# Access Compliance Report
# Public Rights-of-Way
# (Curb Ramps)

**Main Street: BIMINI_DR** | **Cross Street: LA_LIMONAR_DR** | **Location: SE**

**ADA ID: RPRK211013133552** | **Ramp Type:Type 1 - Perpendicular Diagonal Initial Pass/Fail: Pass** | **Overall Compliance: No** | **Severity Score: 20**

## Codes/Mitigation Info/Possible Solution

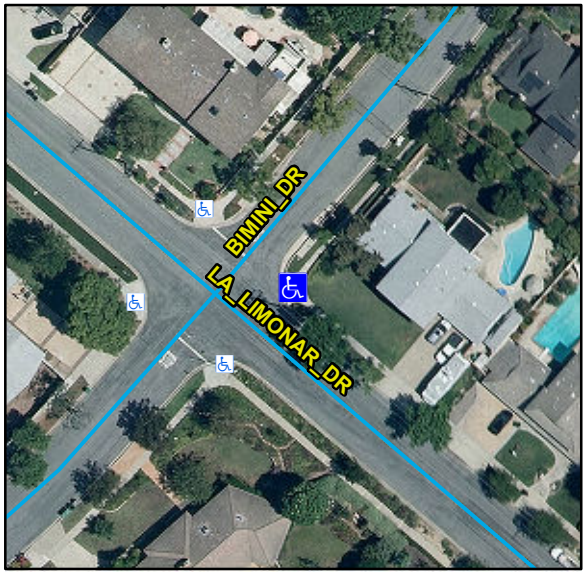
**R204.3, R304.2.1, R304.2.2-Perp, R304.3.2-Para, R304.5.3, R305, STD 1115**

**Remove & Replace Curb Ramp With Two New Directional Ramps or Equivalent.**
